# Addendum No. 03

May 8, 2024

## Universal Transitional Kindergarten Lincoln Elementary School

**PBK PROJECT NO.:** 220486  
**DSA FILE NO.:** 20-30  
**DSA APPLICATION NO.:** 02-121587

IR1.1

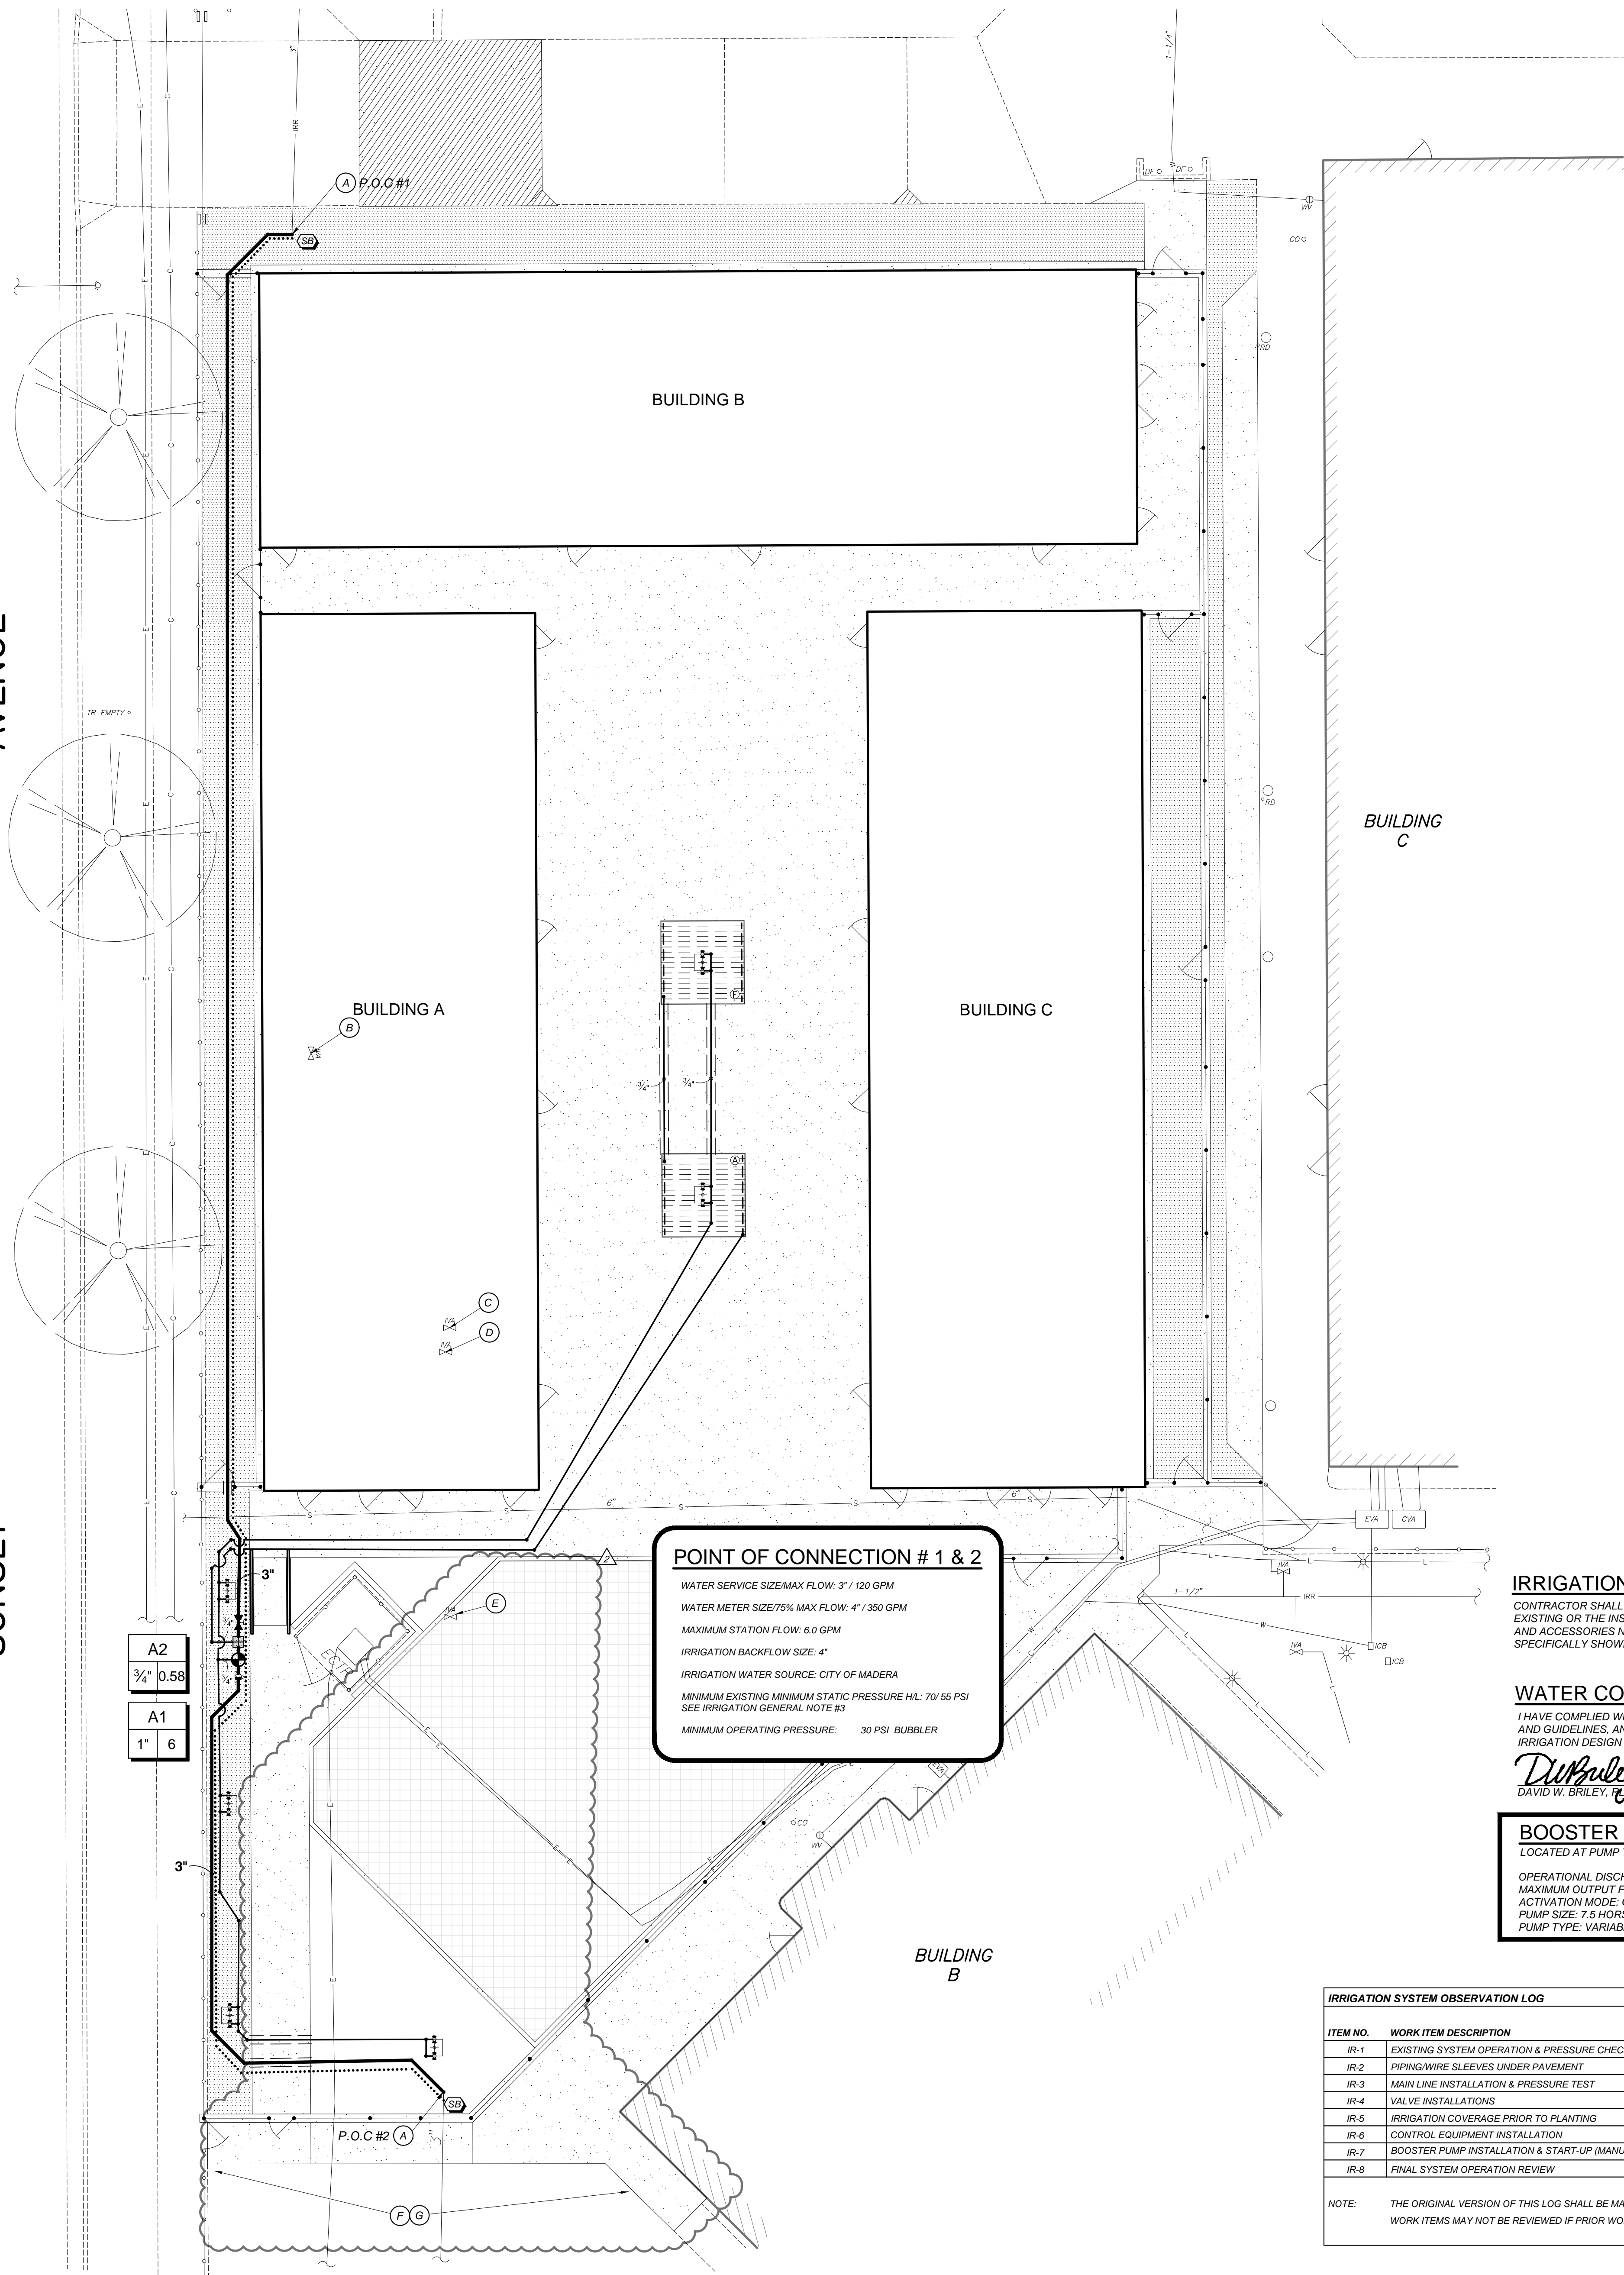
**3-06 IR1.1 – IRRIGATION PLAN**, revise as follows:

- a. Modified irrigation line at revised area and revisions have been clouded with delta 2. Remove and replace with attached drawing.
- b. Added keynotes F and G; revisions have been clouded with delta 2. Remove and replace with attached drawing.
